**April 12, 2018**  
**Staff Report to the Southeast Town**  
**Design Review Committee**

**CASE #MPL2018-10013**  
**SUB2018-10008**  
**Item # 5**

## LAUREATE PARK PHASE 10

### Open Space

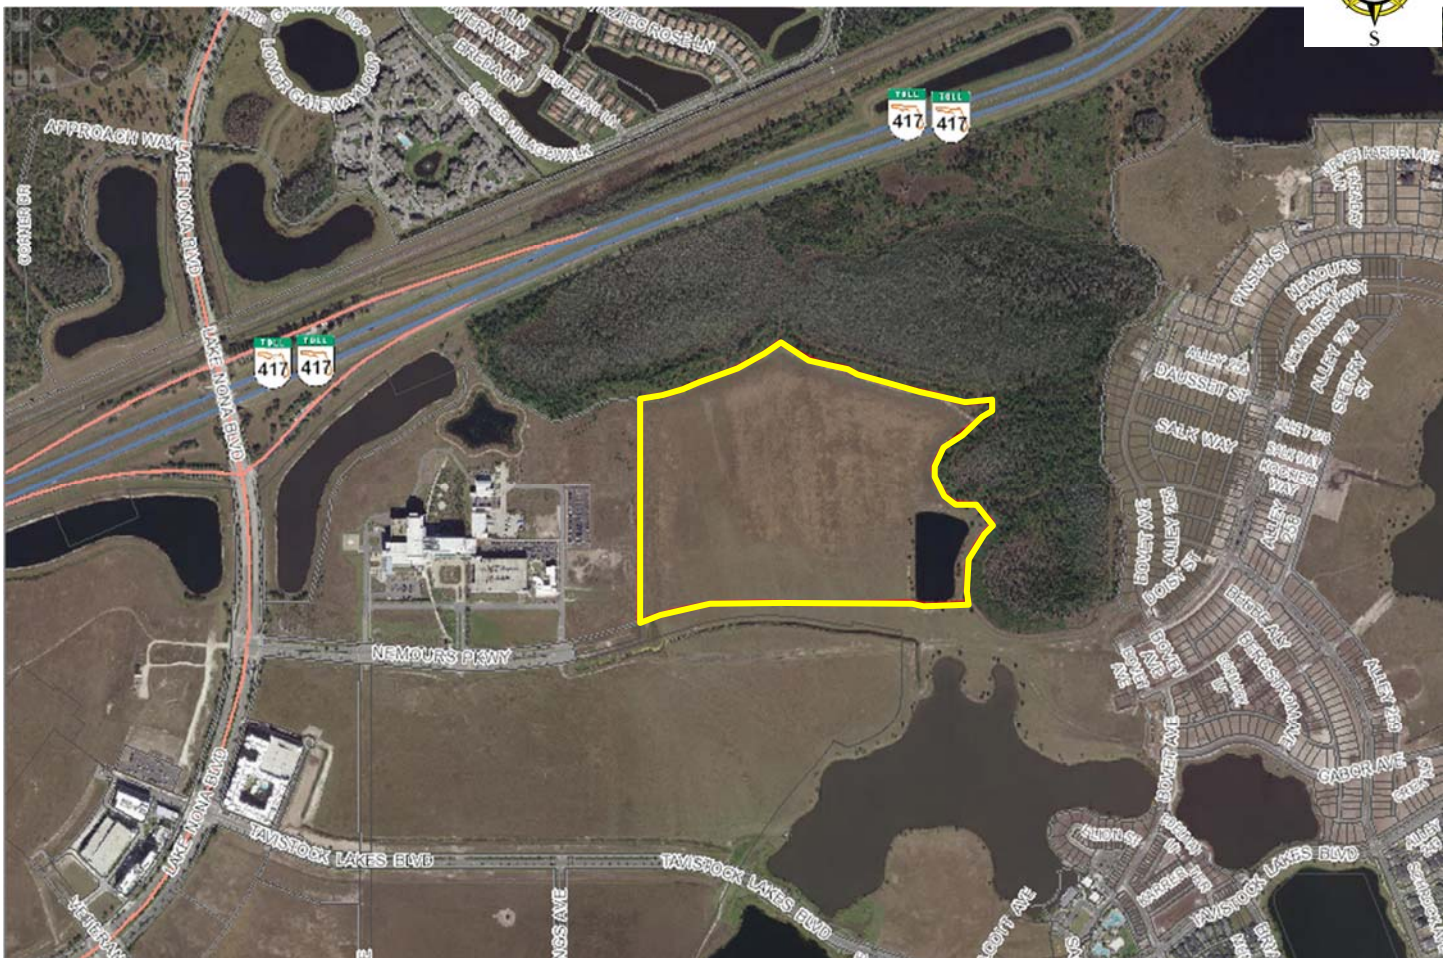
According to Section 68.205(e), *small parks should be located within two to three blocks of every home within a neighborhood. Pedestrian and bicycle connections shall be enhanced to allow surrounding residents to easily and safely access public recreational facilities.* This SPMP depicts open space tracts within the neighborhood that total approximately 3.2 acres in size. The site plan also depicts a multi-use trail on the east side of the development. The Laureate Park neighborhood offers recreational amenities within the Neighborhood Center with an aquatic center and fitness center which is approximately a half mile from the proposed Laureate Park Phase 10 development. Also, the proposed Laureate Park Community Park, with space dedicated to an active and passive parks is less than a mile from the Laureate Park Phase 10 site. The active portion of this community park will have four soccer fields, restroom facilities, a concession area, water amenity and a multi-use trail. To date, for the overall Laureate Park development (all residential phases) there are approximately 49.48 acres of park and open space. With the addition of Phase 10, it will bring the total to 52.68 acres of open space. The neighborhood park Level of Service is 3.25 acres per 1,000 population. Including Phase 10, Laureate Park totals 2,573 dwelling units, yielding a demand of 8.4 acres. The proposed open space greatly exceeds the minimum LOS requirement.

# POTENTIAL MOTOR COURT HOMES LOTS

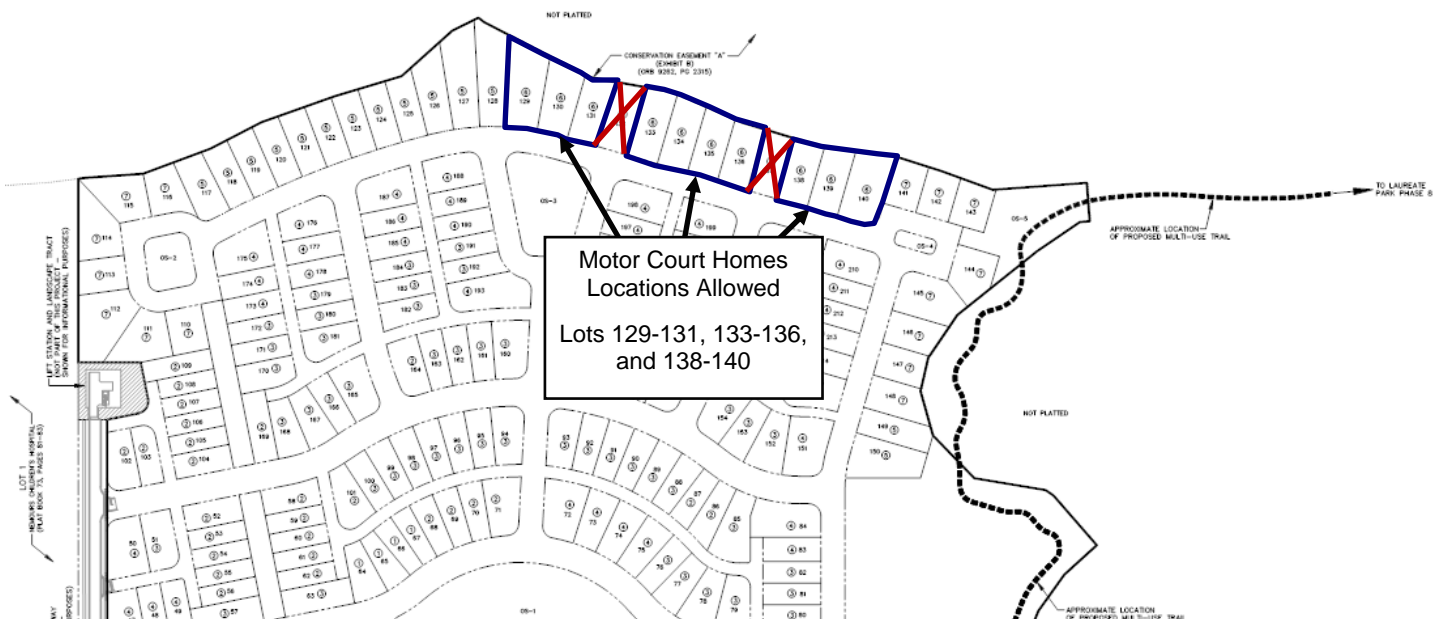
Motor Court Homes are found in other phases of Laureate Park residential neighborhood. The applicant has indicated that this type of product could be proposed in Phase 10. To be consistent with other phases of Laureate Park, Motor Court homes can be allowed on lot types greater than 65'. Therefore, in this phase, the motor court home product can be allowed on 10 lots: Lots 129-131, 133-136, and 138-140. Motor Court homes will not allowed on Lots 132 and 137.

Motor Court Homes are found in other phases of Laureate Park residential neighborhood. Motor Court homes are allowed on lot types greater than 65'. The motor court home product can be allowed on 10 lots: Lots 129-131, 133-136, and 138-140. Motor Court homes will not be allowed on Lots 132 and 137. Motor Courts shall adhere to the following requirements:

- **FRONT YARD SETBACKS**—Motor court homes are permitted to have a minimum front yard setback of 20 feet.
- **GARAGES & DRIVEWAYS**—Garage doors shall be individual decorative doors, no wider than 9 feet and minimum 12" separation or the garage door may be a double garage door provided the top ¼ panel is transparent or the double door includes some level of detail to be approved by the Appearance Review Officer at the time of building permit review. The driveway shall be scored or treated concrete rather than asphalt.
